Sumter City-County Planning Commission

February 25, 2015

PD-04-15 (Phase IV), Hunters Crossing Subdivision – Road Layout Change (City)

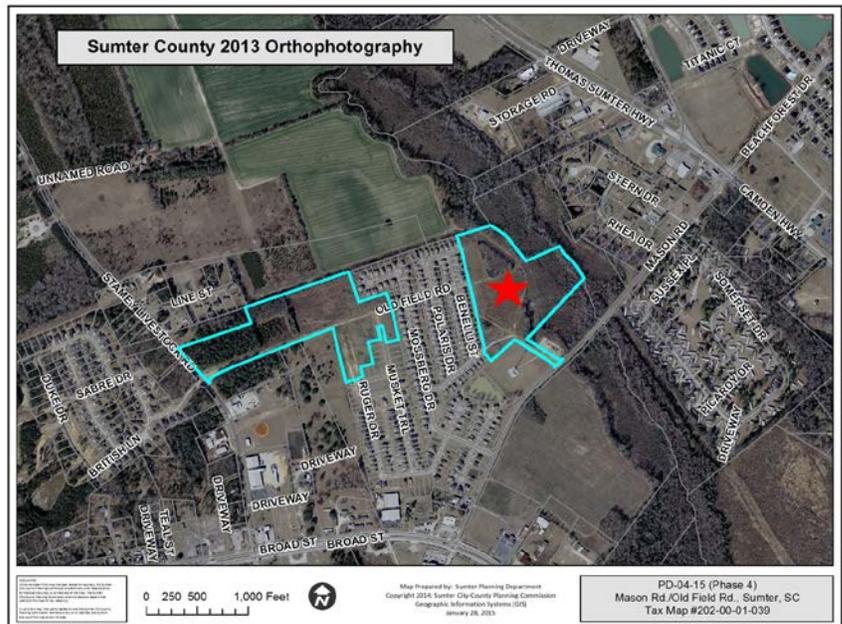
Phase IV revisions are a proposal to reduce the number of lots in area of the development indicated by the red star in the graphic to the right. The proposal is to amend the street layout, sidewalk plan, and open space in what has been termed “Phase IV” of the development.

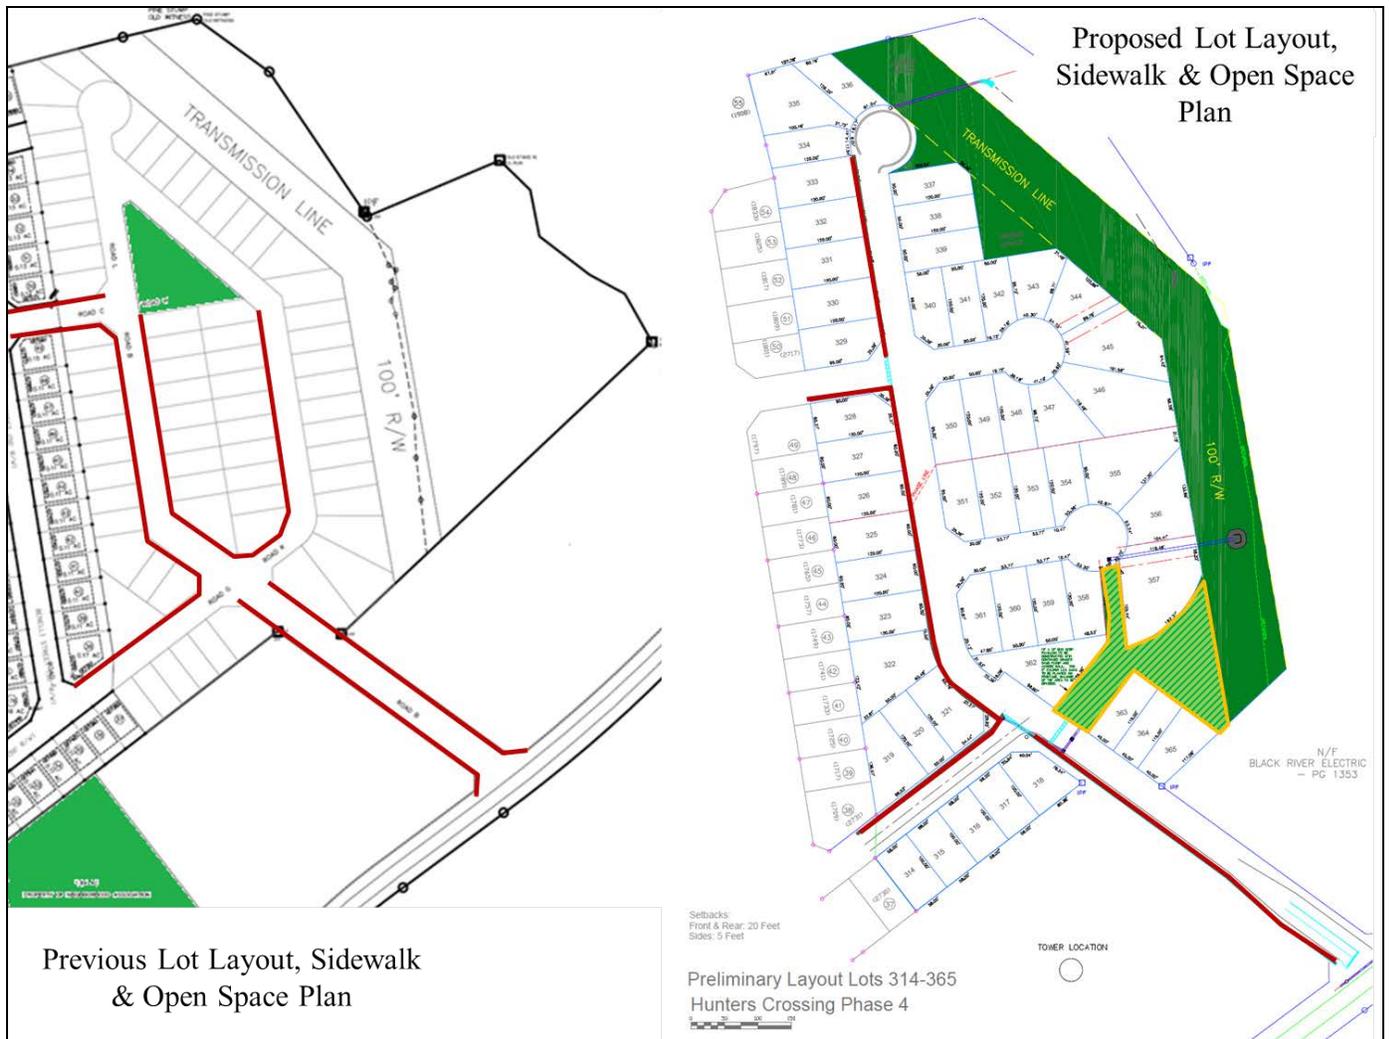
The graphic below depicts the proposed changes in Phase IV. The image on the left is the layout originally envisioned by the developer in 2006 when the Sidewalk Plan was approved. The red lines indicate sidewalk locations and the green area represents open space—the original plan did not consider the power line right of way to be part of the community open space. As originally conceived, this section was to accommodate 70 single family lots.

The proposed layout on the right changes the road network to remove the awkward triangular intersection at the northern point in this phase. The proposed plan creates three cul-de-sac streets with small pockets of open space connecting from north to south through the power line easement behind the proposed lots. The overall number of lots is reduced to 52 from the original 70 units.

As proposed, the small area of open space adjacent to the entrance highlighted in yellow (above right) becomes the practical open space. Although the power line right of way has been shown as reserved for open space, this area is not developable for community amenities due to the

development restrictions in place by the power company for the easement. Additionally, the applicant has proposed construction of a picnic shelter within the front open space, that will serve as a covered bus stop similar to the shelter at the primary entrance to the development.

While the shifting of the community open space is not optimal, the change to the street network improves navigation for the public and the resultant reduction in the number of lots creates a phase within the neighborhood that is less dense than other previously developed areas, offering an alternative within the community. Staff recommends approval of this request with the following conditions:

1. Installation of the sidewalk from the Mason Rd. Entrance to Lot 318 prior to final plat approval for Phase IV, Section 1.
2. Construction of the Picnic Pavilion prior to final plat approval for Phase IV, Section 1.

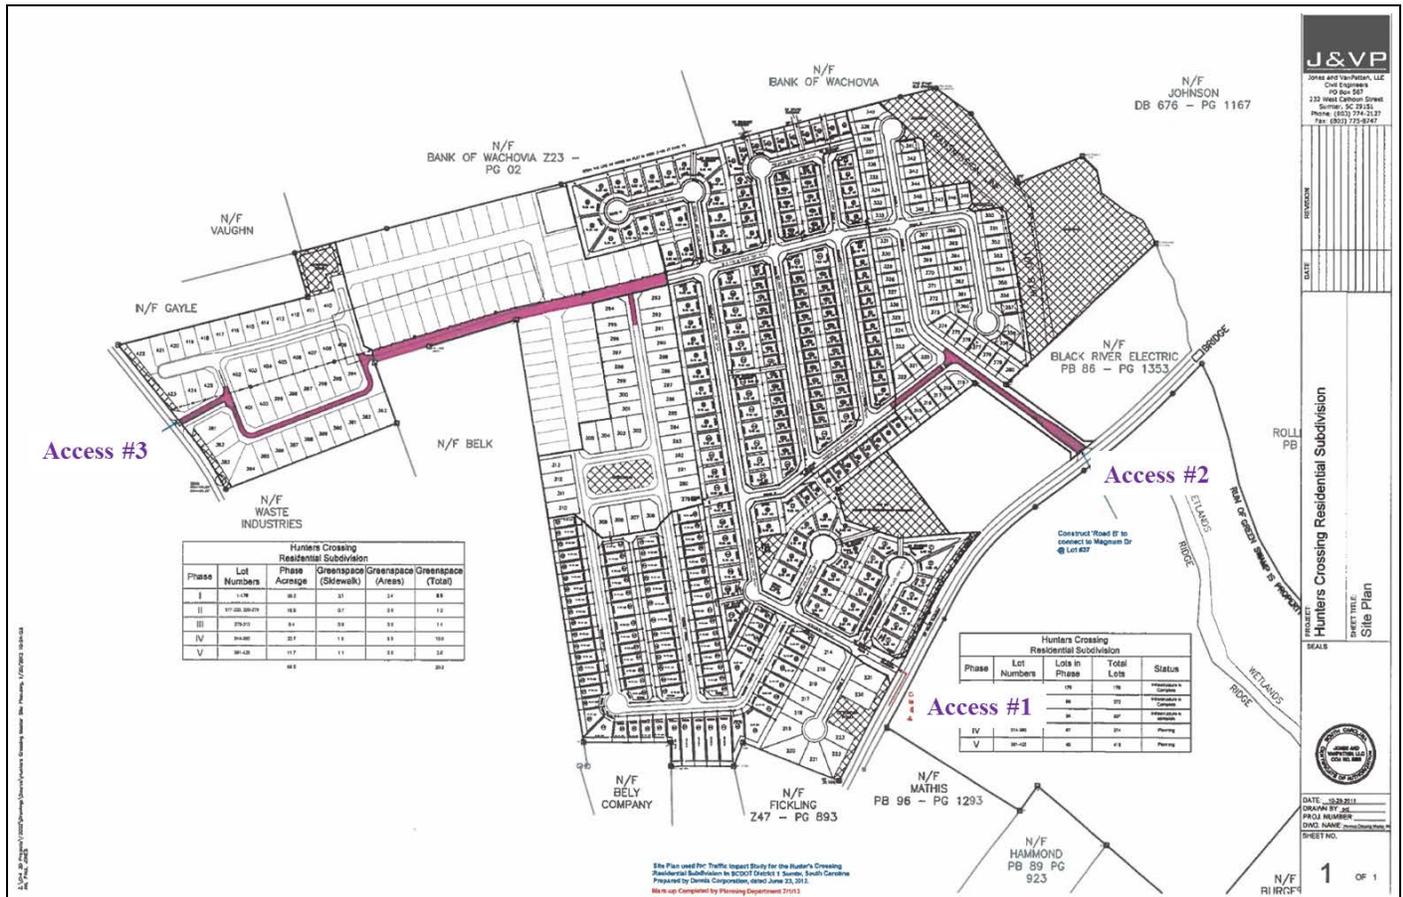
The TIS assumes the construction completion of all three access points shown in the graphic below—one at the current primary access on Mason Rd. (Access #1), one access point further north on Mason Rd. (Access #2), and an access point on Stamey Livestock Rd. that aligns with the Williamsburg Subdivision Entrance (Access #3). Mitigation recommendations by the Study include implementation of an auxiliary left-turn lane at Access #1 on Mason Rd.

- Implementation of the auxiliary left-turn lane at Access #1 on Mason Rd. shall be completed no later than September 1, 2016. If the turn lane is not constructed by September 1, 2016 no further permits for new construction shall be issued.
- Installation of Access #2 to be completed no later than May 31, 2015. If the installation of Access #2 is not installed by May 31, 2015 no further permits for new construction shall be issued.
- Access #3
 - Road bed shall be graded and filled to eliminate potholes, etc. and made passable for emergency vehicles no later than January 1, 2015. ***This benchmark has been met and the road is being maintained for public safety vehicles.***
 - Full paving of Access #3 shall be completed prior to issuance of the building permit for the 381st dwelling unit.

Development of Phase IV will address installation of Access #2 as outlined above.
